Addendum No. 1

Contract No.: DA00169

WBS No.: 42999.3.1

*Drainage, Grading and Paving to improve curve radius on SR 1227 (South Mills Rd.),
Currituck County*

REVISED: 9-26-2013

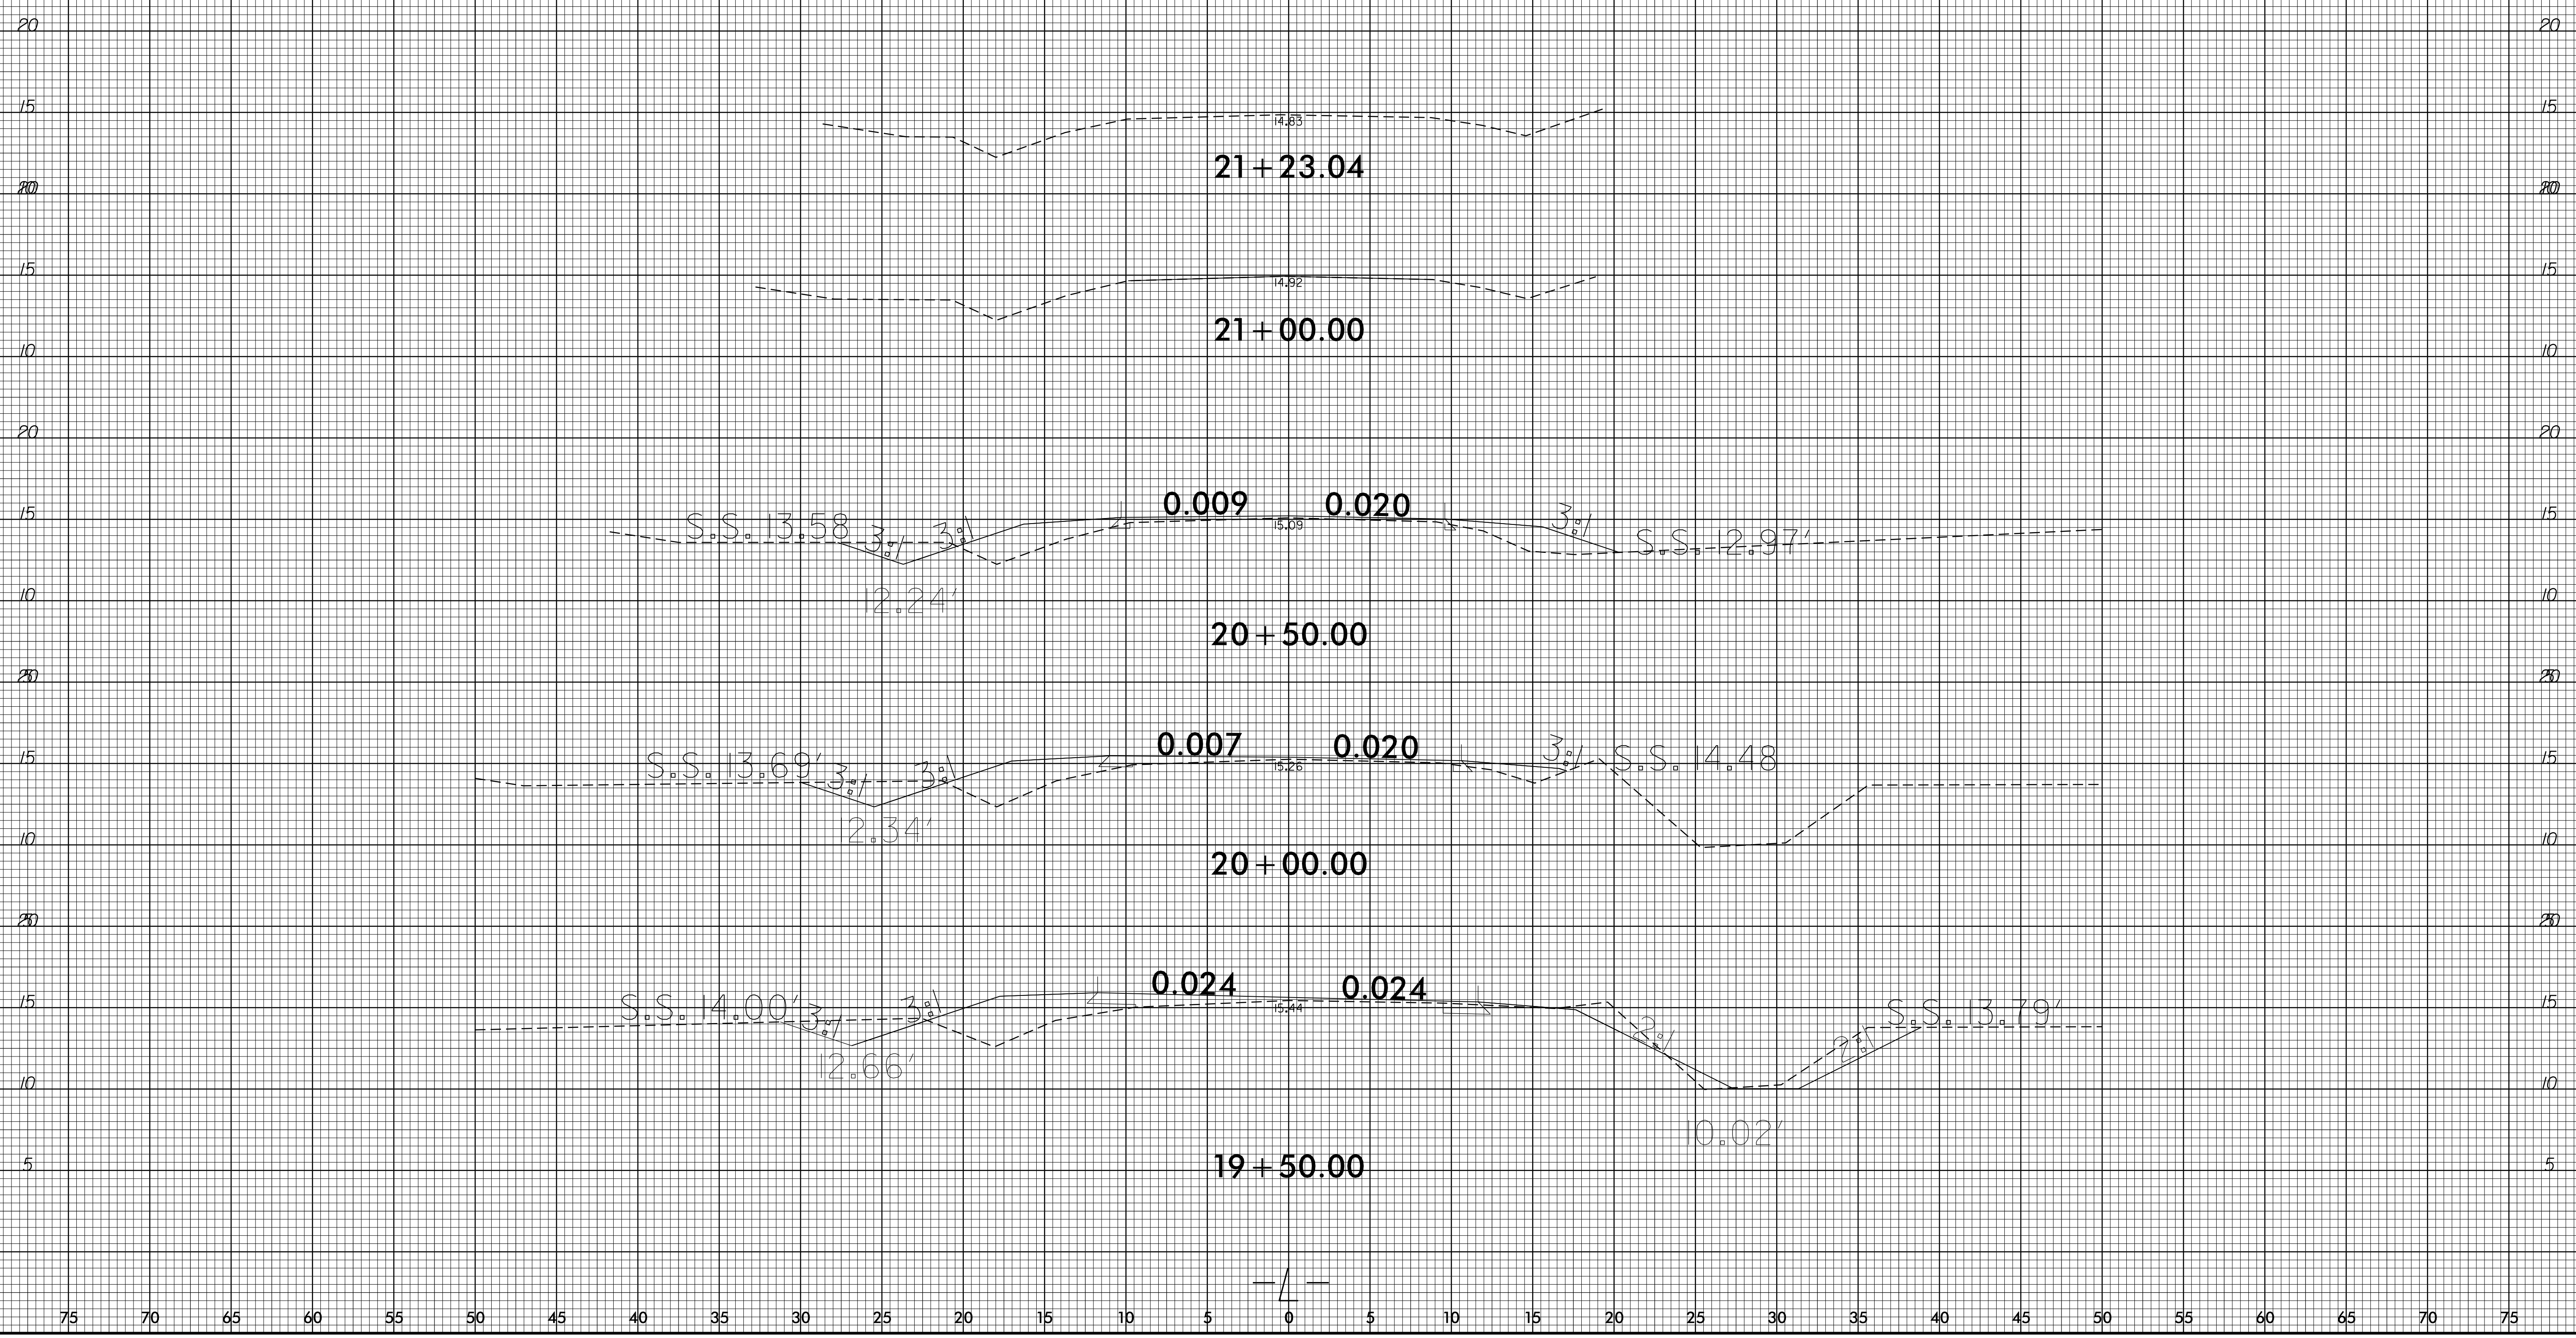
Plan Sheets X-1 to X-5 have been updated to illustrate the revised centerline profile." Please void the existing Plan Sheets X-1 to X-5, in the proposal and staple revised Plan Sheets X-1 to X-5 thereto and acknowledge addendum on the Bid Form.
